# CITY OF ALBUQUERQUE

**RE: Lot 9 Block 2 Unit 28 SAD 227  
6708 Rimrock NW  
Grading and Drainage Plan  
Engineers Stamp Date 2/21/2020 (D10D019)  
Pad Certification Date 8/14/2020**

## DRAINAGE AND TRANSPORTATION INFORMATION SHEET (REV 6/2018)

<div>ENGINEER'S SEAL</div> <div></div> <div>DAVID SOULE P.E. #14522</div>	6708 RIM ROCK	DRAWN BY: WCUJ
	GRADING AND DRAINAGE PLAN	DATE: 5-20-20
	 1606 CENTRAL AVENUE SE SUITE 201 ALBUQUERQUE, NM 87106 (505) 872-0999	2102039-LAYOUT-5-20-20
8/14/20		SHEET #
		JOB # 2102039

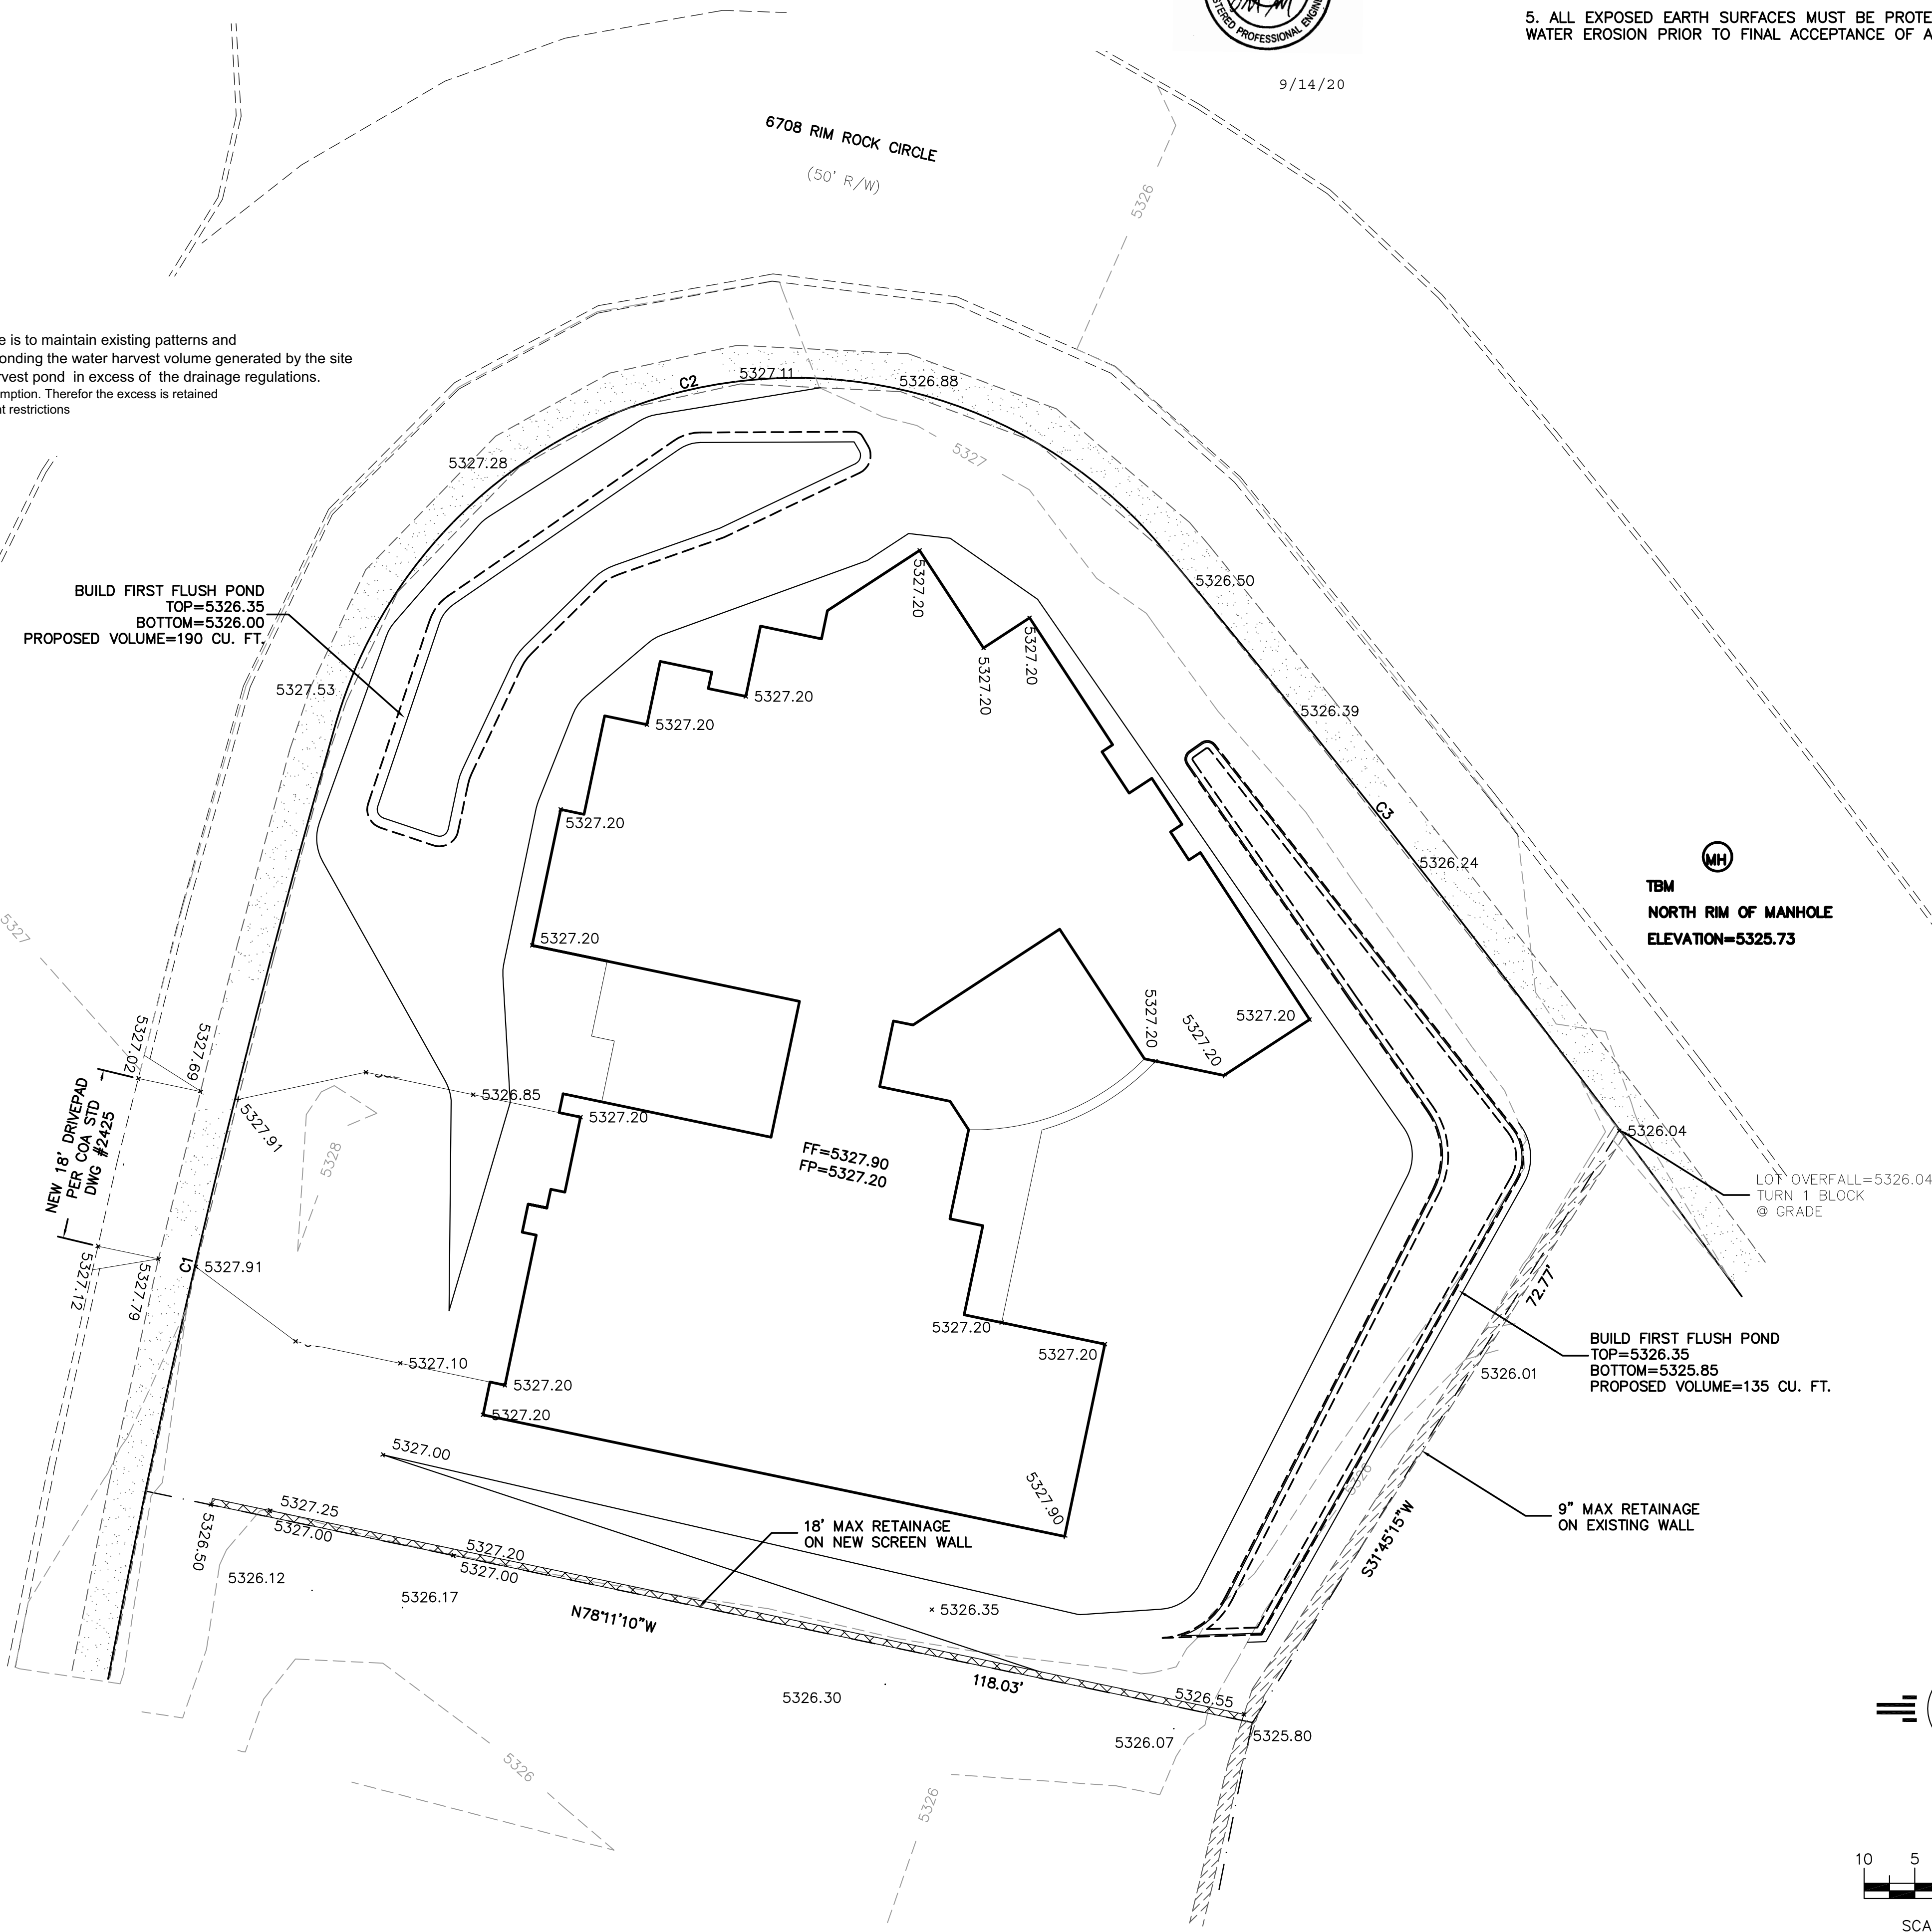
Based upon the information provided in your submittal received 9/15/2020, this plan is approved for Building Permit.

Reiterate to the Owner/Contractor that a separate permit for a garden/retaining wall must be obtained, with the approved G&D plan.

Prior to Certificate of Occupancy release, Engineer Certification per the DPM checklist of this plan will be required.
